Proposed Gooding Avenue Hotel

Conclusion

Storm Chamber SC - 740 is being discontinued - Recommend Use SC-800 (ADS)

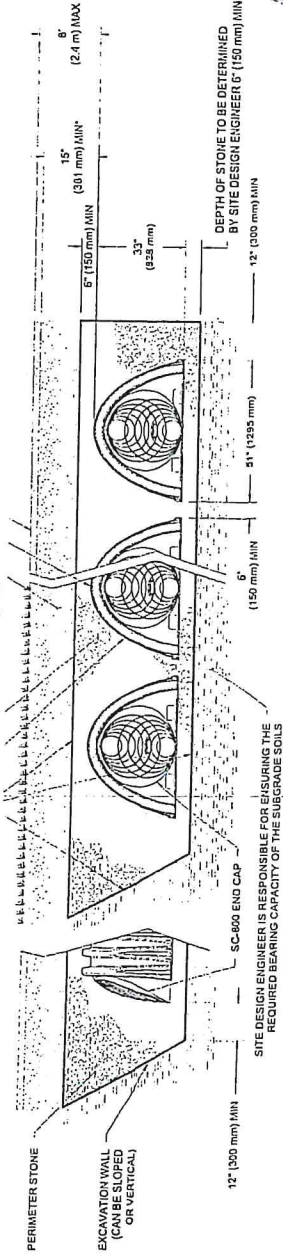
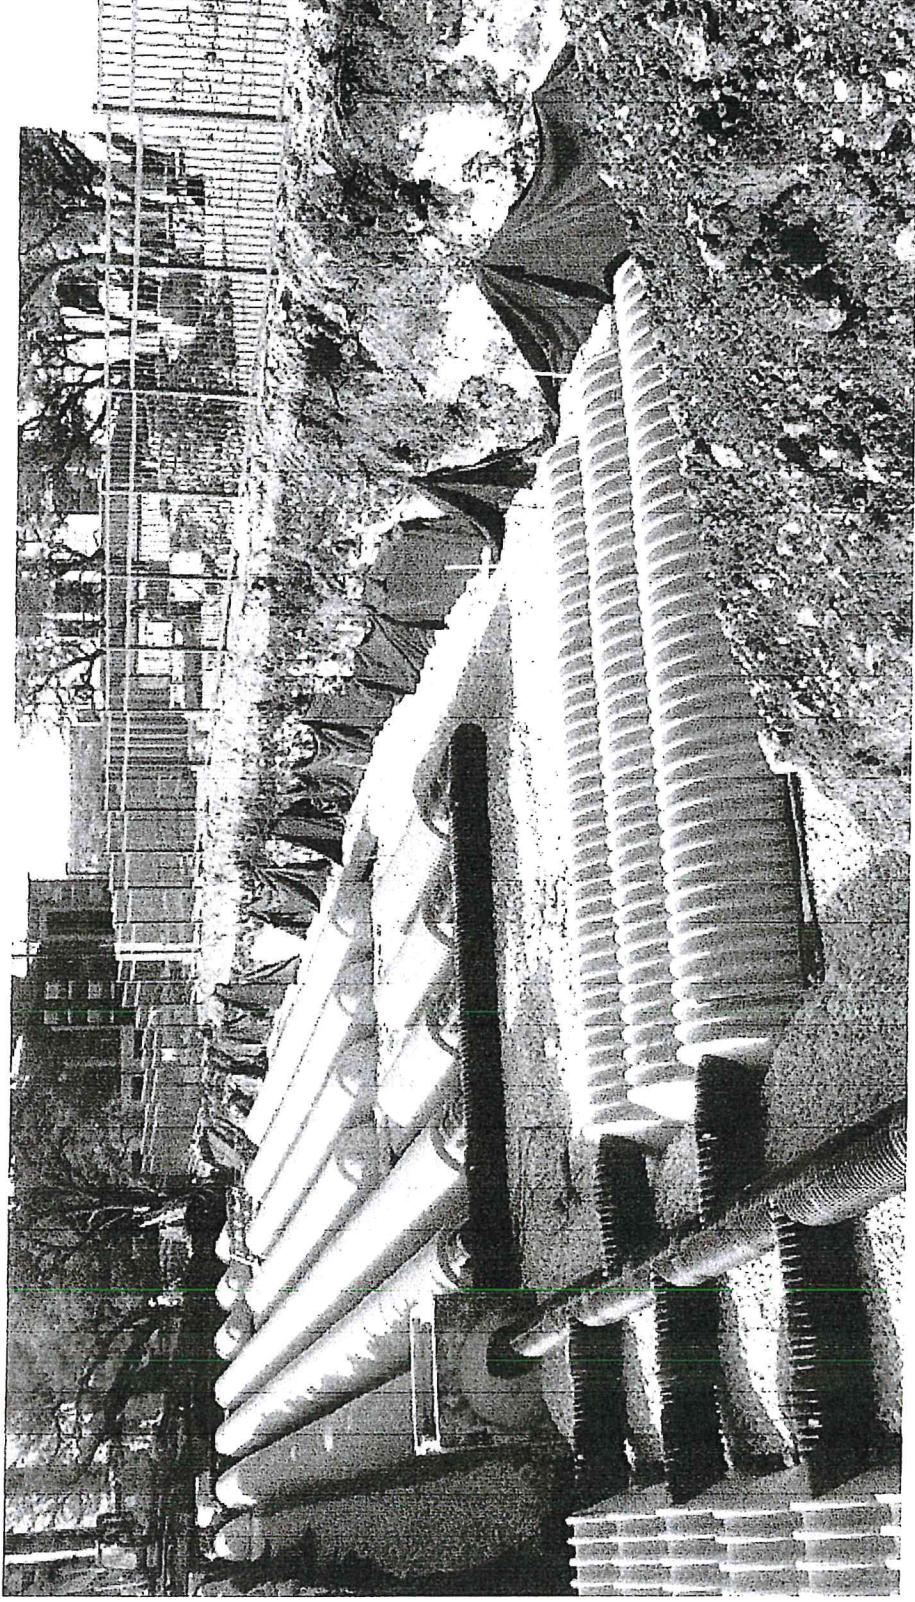
Different Profile

The SC-740 is in limited stock and will eventually be discontinued. Refer to the SC-800 for all of your design needs.
